**SERVICE BULLETIN**

**APPLICABILITY:** 2017-21MY Impreza

**NUMBER:** 05-82-21

**SUBJECT:** Front Strut Dust Cover- Design Change

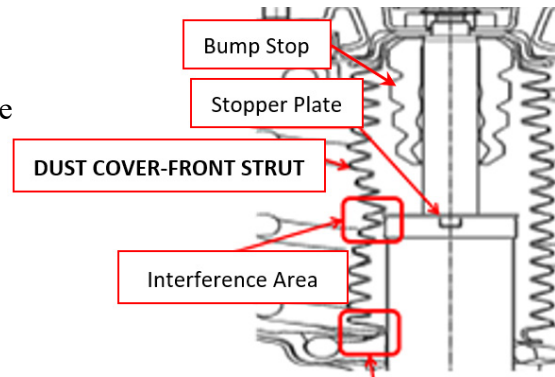
This bulletin announces a design change made to the front strut dust cover to address a rubbing -type sound concern. The inner diameter of the lower portion of the cover may interfere with the strut assembly stopper plate while driving when the strut compresses and cause the sound.

Inner diameter of the dust cover has been reduced by 2.4mm to prevent the rubbing sound.

The part number for the new Dust Cover is **20322FL00B**.
